FR Technical Regulations Bulletin

No: FR-TRB-2026-04
Date: August 27, 2026
Subject: Summer Break Updates

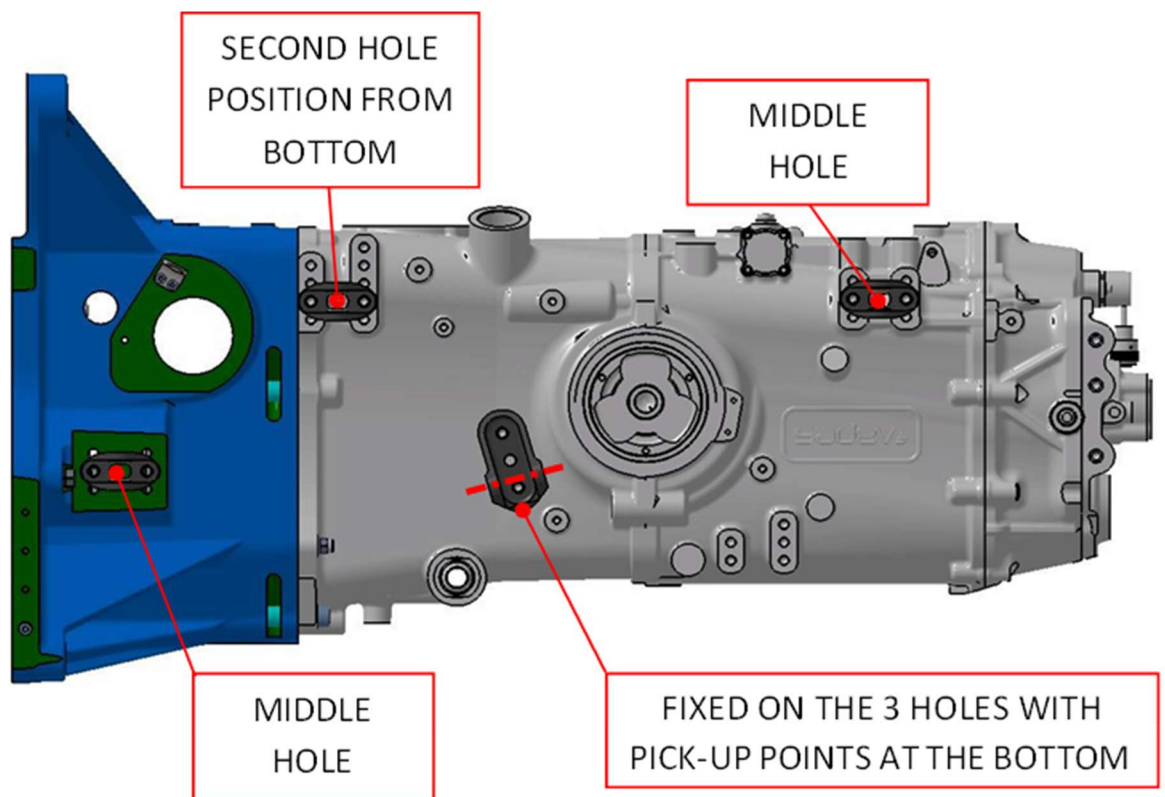
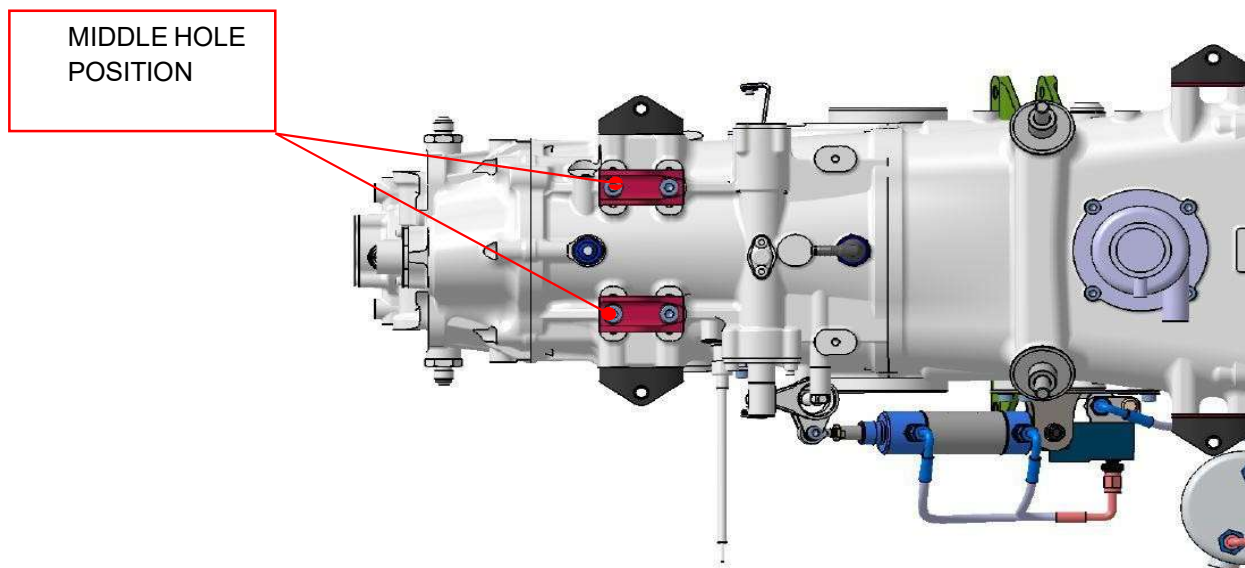
Article 26.3.4.a Suspension, Wheels, and Brakes – There is no change to this rule. This language update is to simply clarify this rule and add the diagrams from the vehicle information manual to the rule book. Change this section to read as follows.

- a) The use of the rear suspension pickups points, including the rear shocks, as shown in the [Ligier JS F318 Vehicle Information manual](#) is mandatory. The vehicle information manual and parts list are part of the homologation documentation. Below are the diagrams from the information manual specifying the required mounting locations.

If the mounting holes are damaged, Helicoils, or other types of repair mechanisms, may be used to repair the suspension mounting points in the transmission case.
